August 24, 2015
RC-15-0125

Subject: VIRGIL C. SUMMER NUCLEAR STATION (VCSNS), UNIT 1
DOCKET NO. 50-395
OPERATING LICENSE NO. NPF-12
FIFTH SIX-MONTH STATUS REPORT IN RESPONSE TO MARCH 12, 2012,
COMMISSION ORDER MODIFYING LICENSES WITH REGARD TO
REQUIREMENTS FOR MITIGATION STRATEGIES FOR BEYOND-DESIGN-
BASIS EXTERNAL EVENTS (ORDER NUMBER EA-12-049)

**FIFTH SIX-MONTH STATUS REPORT FOR THE IMPLEMENTATION OF ORDER
MODIFYING LICENSES WITH REGARD TO REQUIREMENTS FOR MITIGATION
STRATEGIES FOR BEYOND-DESIGN-BASIS EXTERNAL EVENTS
(ORDER EA-12-049)**

Figure 4 – Conceptual Strategy for Reactor Makeup and Reactivity Control

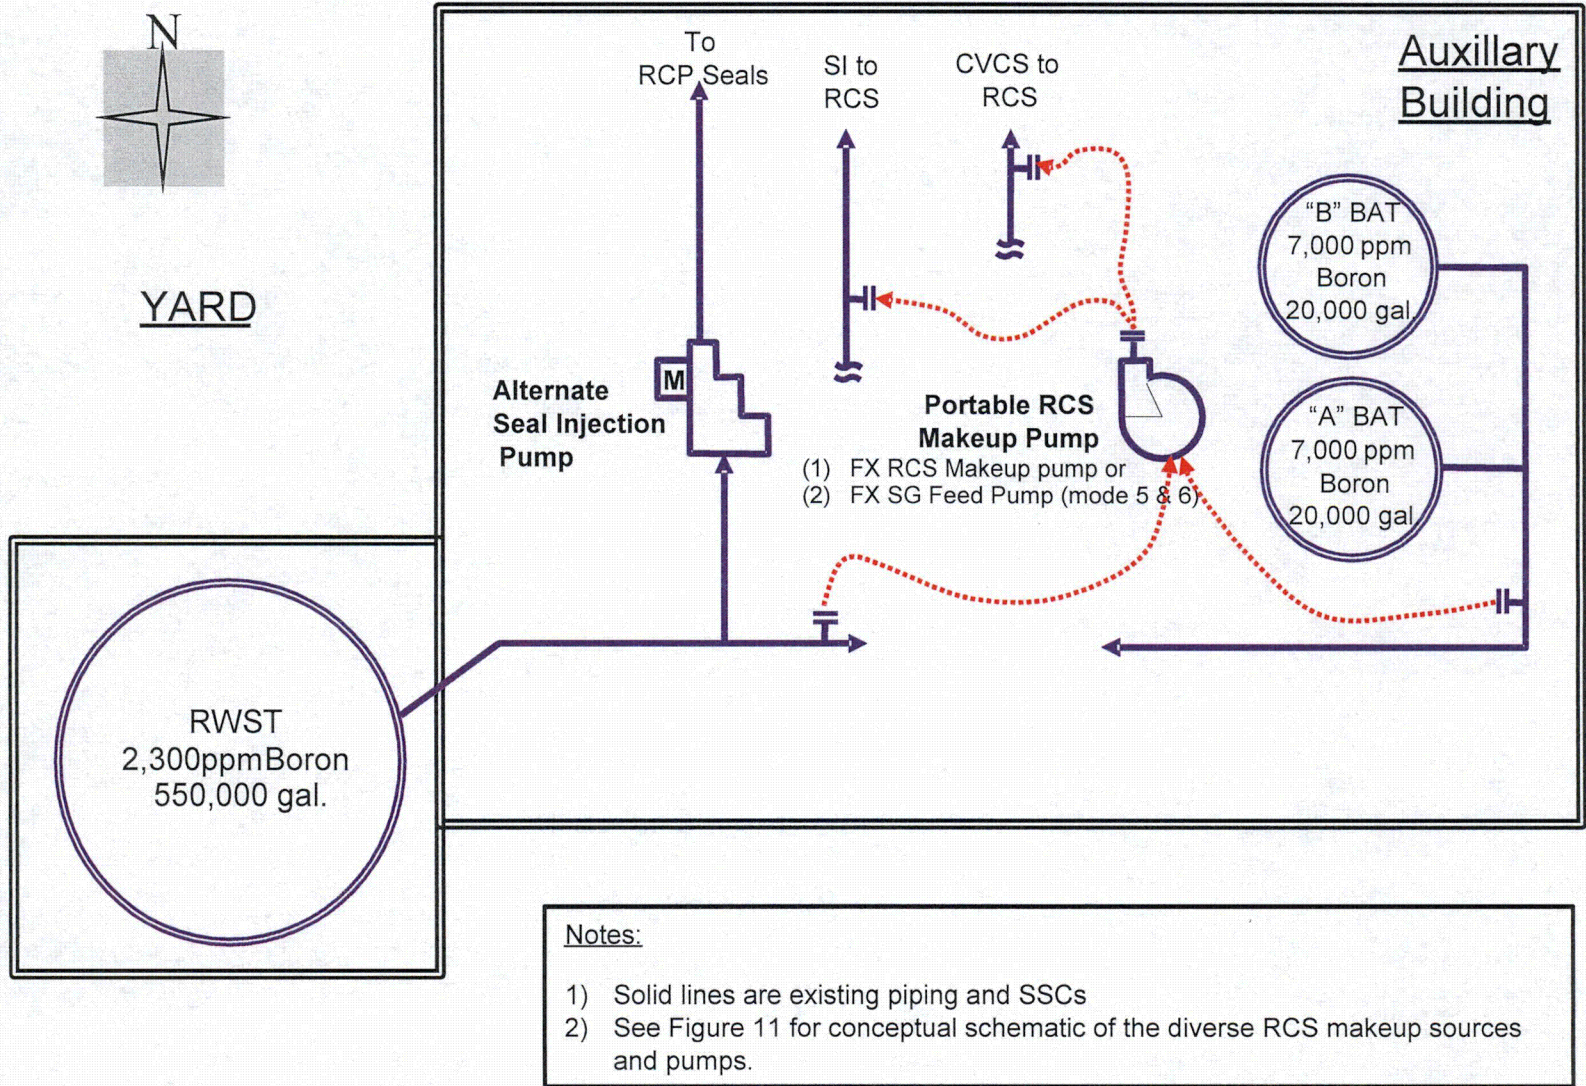
4. Change: The strategy for Reactor Coolant System (RCS) inventory and reactivity control, Phase 2, included use of the station's installed Alternate Seal Injection (ASI) pump and a portable FLEX RCS Makeup Pump (FX RCS MU PUMP). The strategy has been changed to credit two FX RCS MU PUMPS.

5. Change: The strategy for RCS inventory and reactivity control, Phase 3, has been modified to include a mobile boration skid. The skid will be provided by the National SAFER Response Center (NSRC).

Figure 5 – Conceptual Coping Strategies for Support Functions from EB

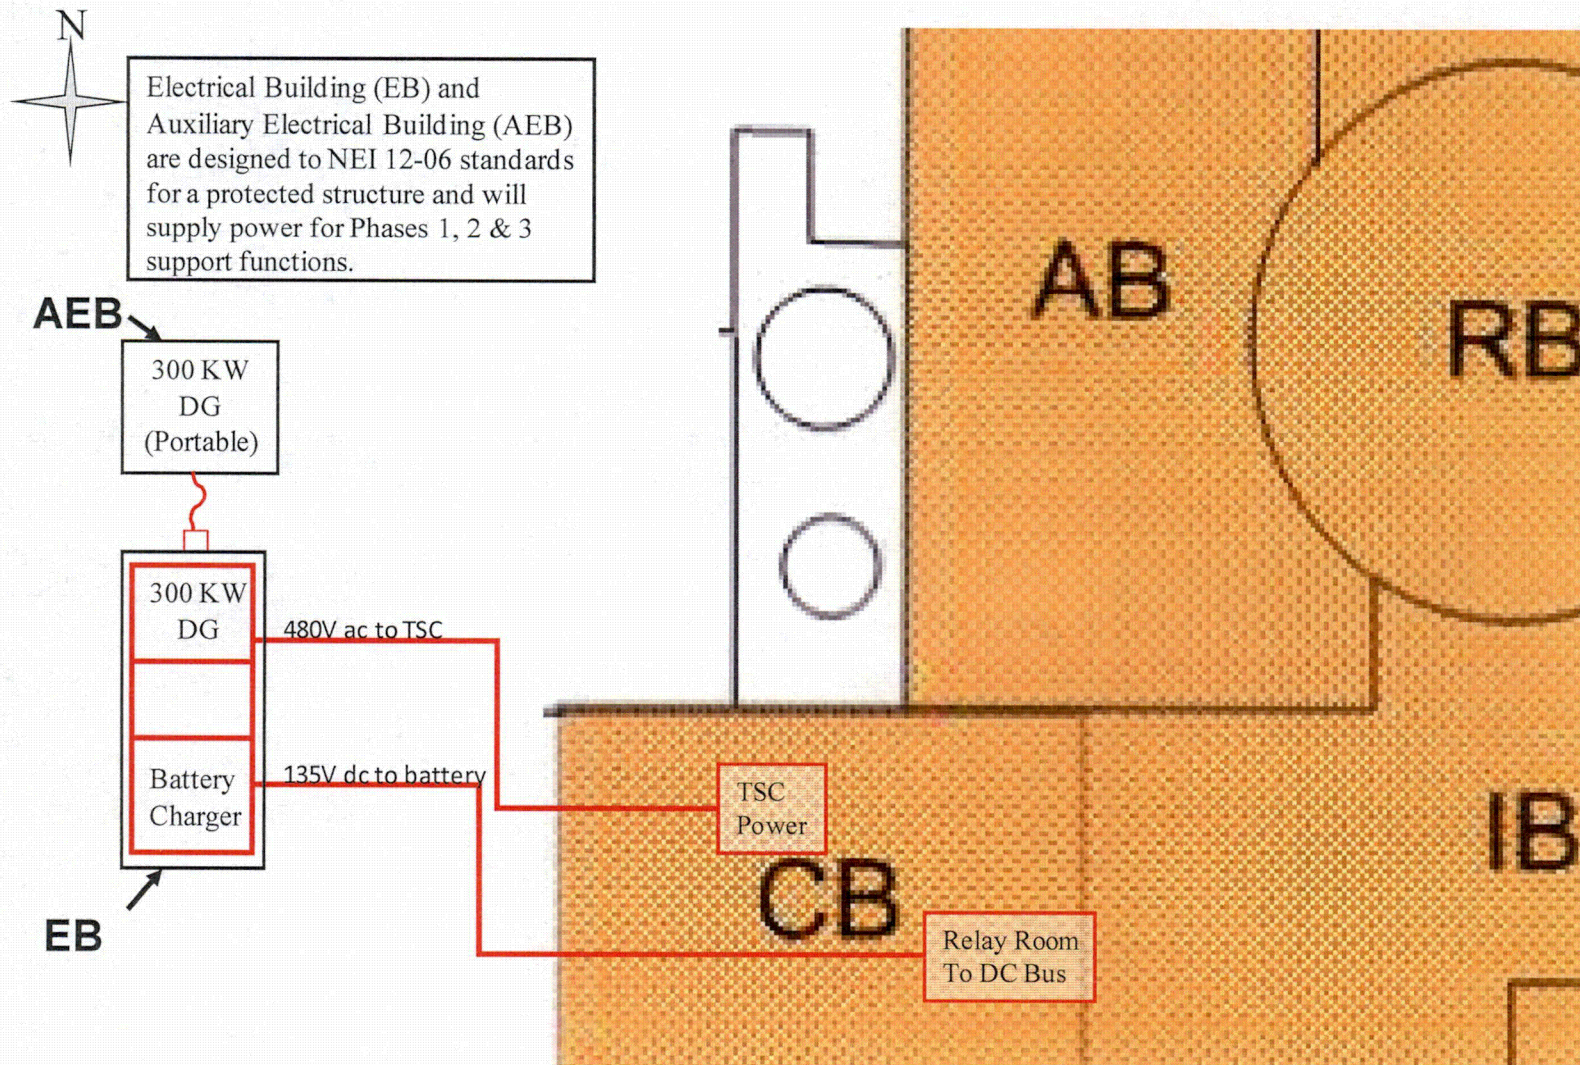
7. Change: Two methods for extending DC power availability, Phase 2, are being added to the Safety Function Support strategies. These methods will utilize B5b equipment. One method uses a portable 80kW generator and AC distribution panel to supply AC power to the input of the Station Battery Chargers. The second method uses a portable 80kW generator and a portable battery charger to supply DC power to the output of the station battery chargers. The equipment for one method will be stored in the ERB and the equipment for the other method will be stored in the FSB.

Figure 7 – Conceptual Strategy for Supplying SG Makeup Using Alternate EFW Suction

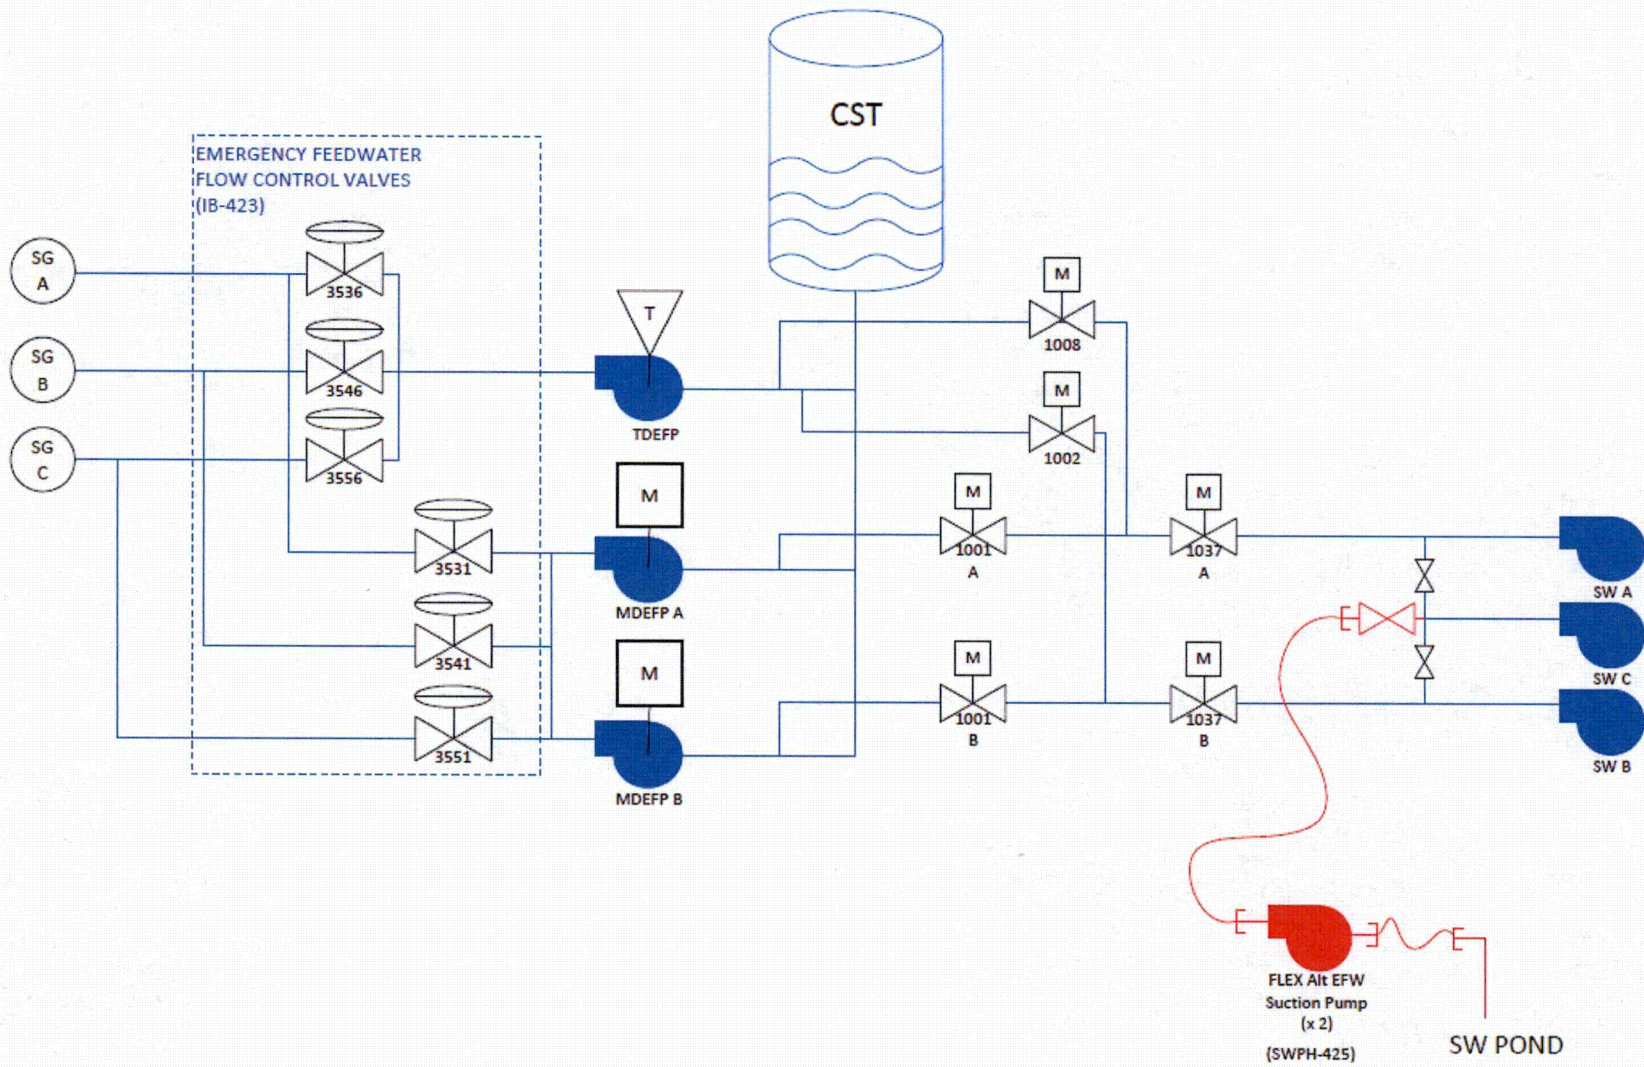
2. Change: In order to maintain core cooling during Phase 2, the primary strategy is being modified to include an alternate suction source for the Emergency Feed Water (EFW) pumps in the event the minimum Condensate Storage Tank (CST) inventory is not immediately available. A FLEX Alternate EFW Suction Pump will transfer water from the Ultimate Heat Sink (UHS) to the 'C' Service Water (SW) Pump header to allow alignment to any EFW pump via the design basis SW to EFW flow path.

Justification: The CST does not meet the hazard protection requirements concerning high winds from tornados documented in NEI 12-06, *Diverse and Flexible Coping Strategies (FLEX) Implementation Guide*, Revision 0. Therefore, the CST is not creditable for FLEX. This change will ensure a strategy exists to cope with all applicable beyond-design-basis external events (BDBEE).

Figure 8 – Conceptual FLEX Feed Hose Layout

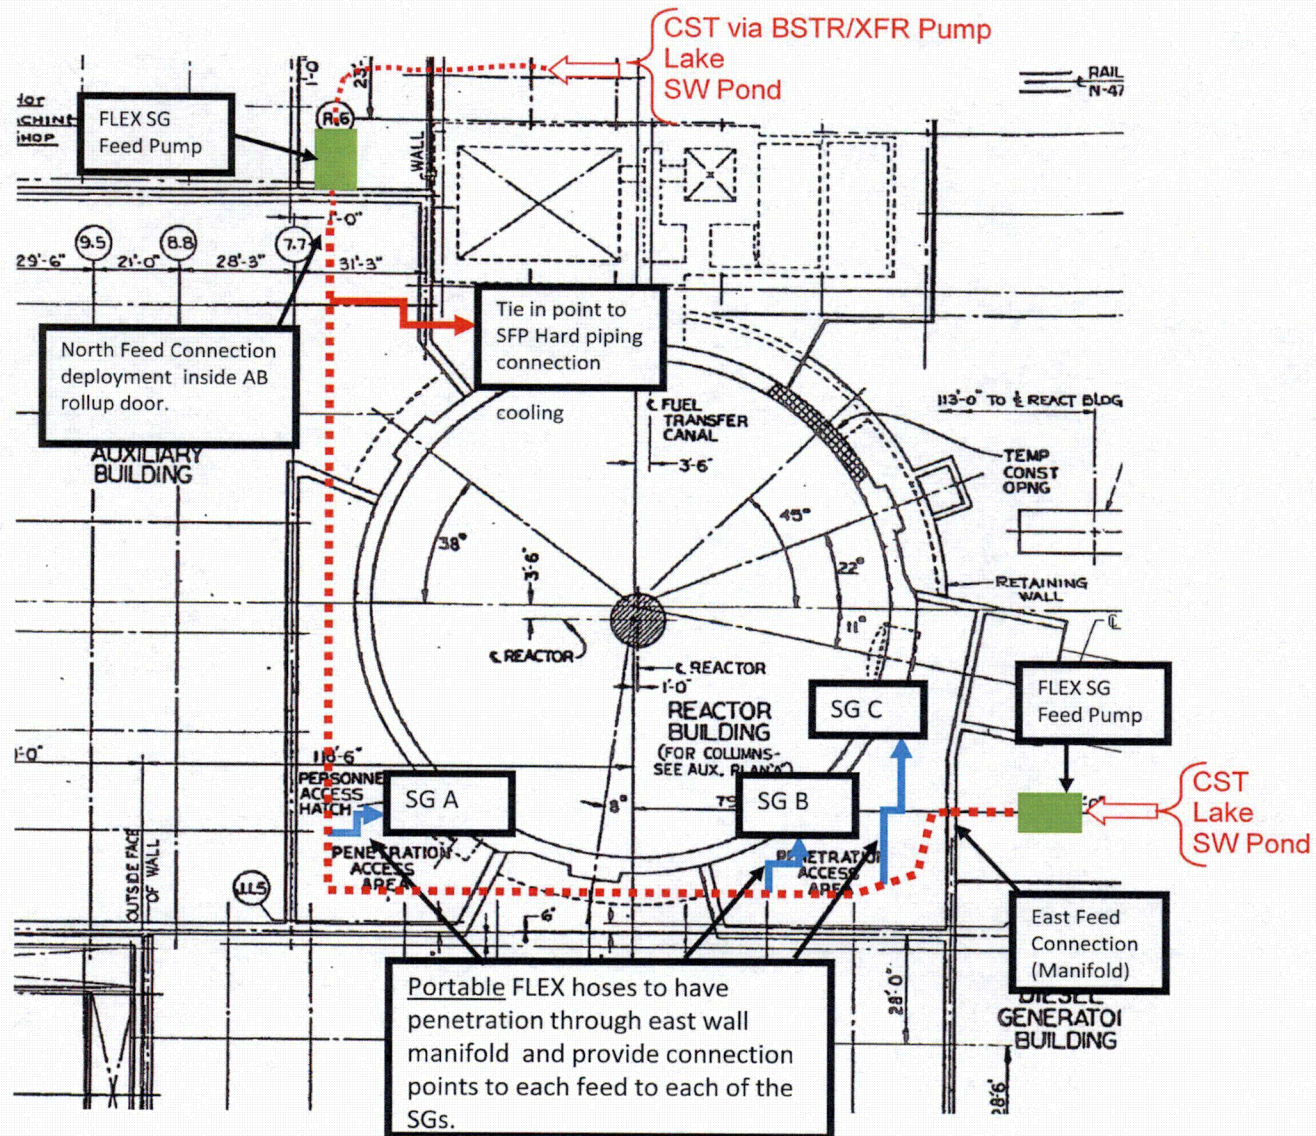
8. Change: The following figures have been revised to reflect current strategies. The updated figures are provided within Attachment 2 of this report.
